TPS2549-Q1 Production Silicon Change List

Silicon Bug Description: CDP/SDP Auto-Switch Function is Incorrectly Occurring in CDP Mode

Figure 1. CDP/SDP Auto-Switch Occurs Incorrectly

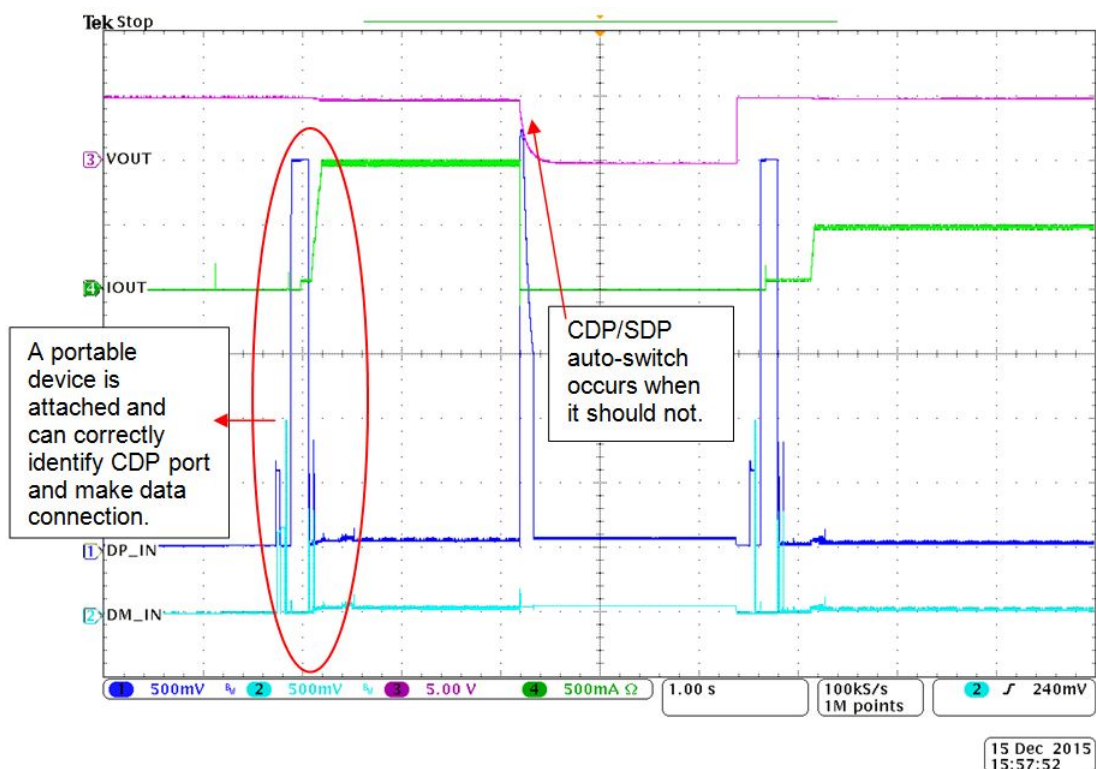
The CDP/SDP auto-switch function in TPS2549-Q1 is meant to occur when a portable device never signals connection and enumerates. However, the silicon bug discovered makes the CDP/SDP auto-switch function incorrectly occur after a portable device has successfully established data communication as [Table 1](#) shows.

The CDP/SDP auto-switch bug will disable fast charging when the TPS2549-Q1 is configured in CDP mode. The bug prevents the portable device from fast charge as the TPS2549-Q1 switches to SDP mode and may also result in data communication loss due to VBUS discharge as shown in [Figure 1](#).

Unfortunately there is no work around where fast charge and data communication are needed in same mode. Use DCP mode to fast charge the device if data communication is not needed, or SDP mode for data communication if fast charging is not needed.

TI has fixed the CDP/SDP auto-switch bug in silicon, see the first page of this change notification for details.
